For Ramp A5	Job no. 49633	Sheet no.
Made by LER	Checked by KDG	Backchecked by LER
Date 11/28/11	Date 11/29/11	Date 11/29/11

Abut. Modification - Pile Layout

Ramp A5 - Abutment Pile Layout

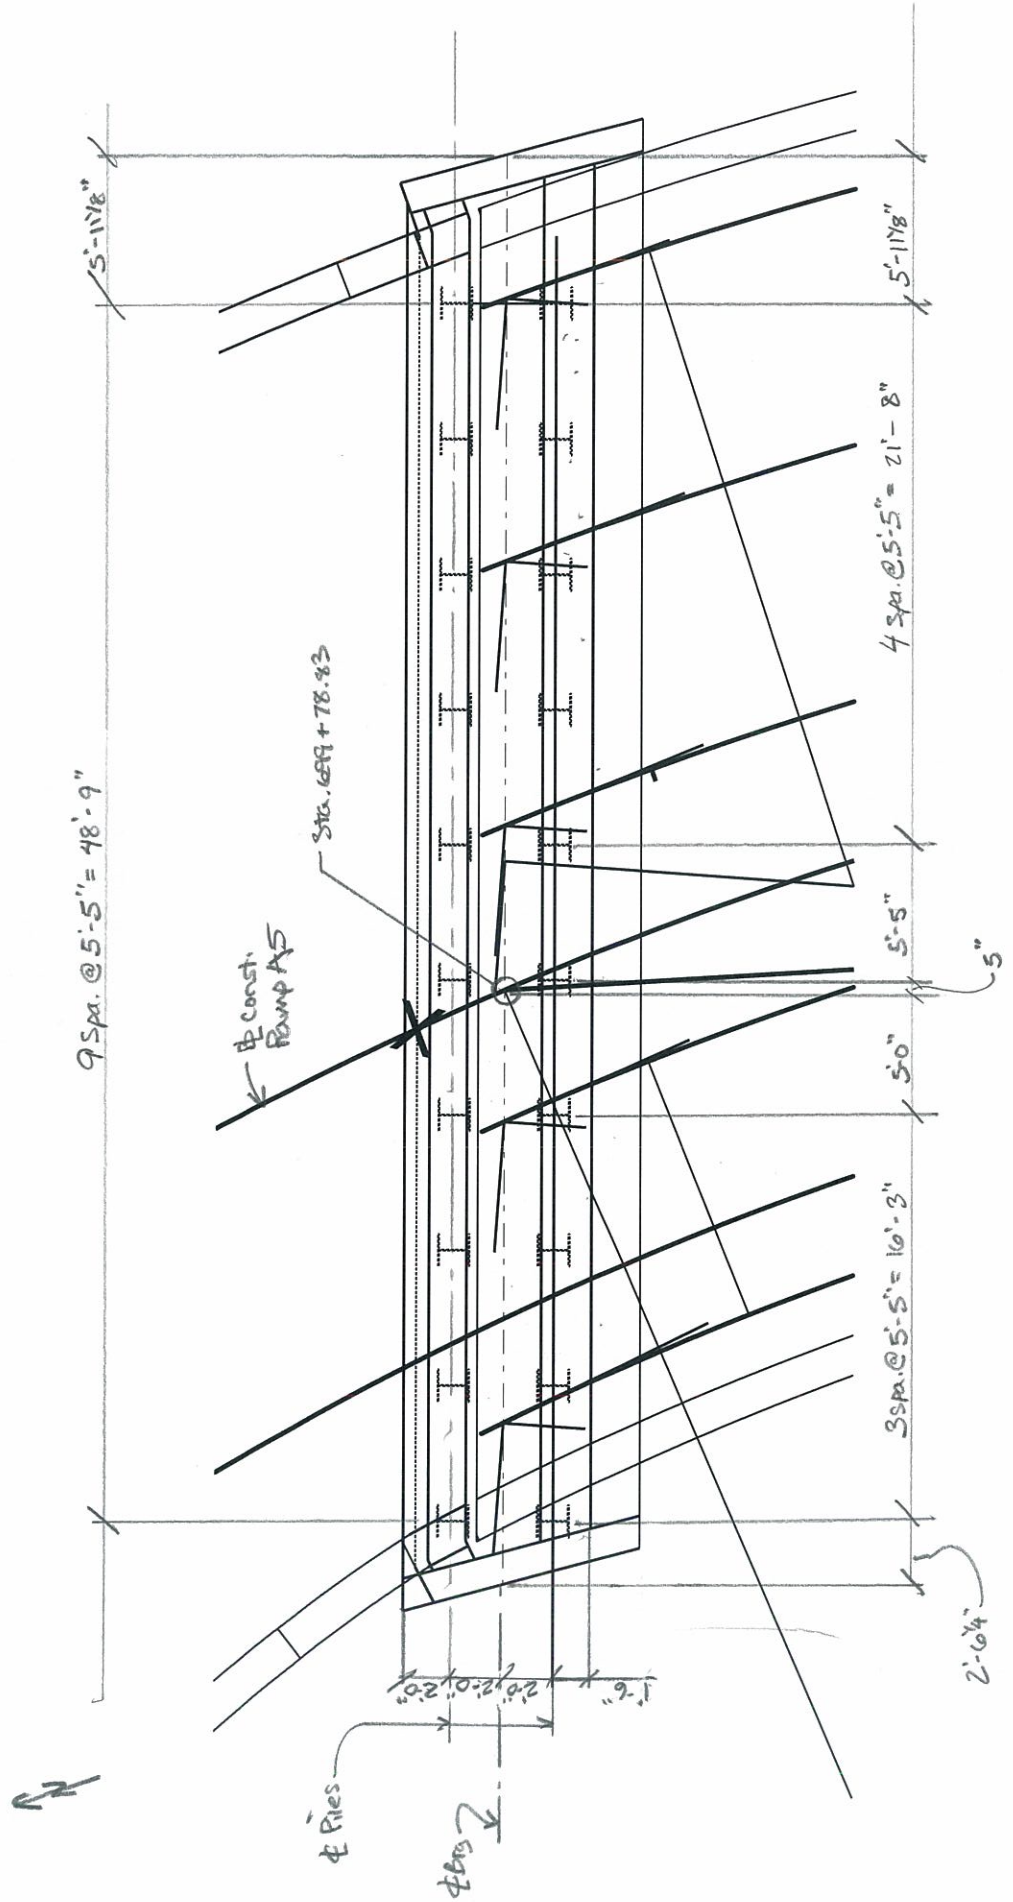
The contractor has proposed to modify the pile layout such that the front and back rows of piles will be in-line (i.e. not staggered).

The current design ignored the stagger, therefore there will be no changes required to no. piles or est. pile length.

Shifting the front row of piles towards the west creates a larger cantilever on the east end of the abutment footing.

The girder reaction at this end aligns with the ϕ of the outermost set of piles.

Verify that the footing reinforcement will be adequate to support the DL of the abutment.

$$\begin{aligned} M &= \frac{1}{2} w l^2 = \frac{1}{2} (13.5) (6.0)^2 \\ &= 243 \text{ k}\cdot\text{ft} \end{aligned}$$

$$M_u = 1.25 (243) = \underline{304 \text{ k}\cdot\text{ft}}$$

$$\phi M_n = 770.8 \text{ k}\cdot\text{ft} \text{ (from design calcs.)}$$

OK
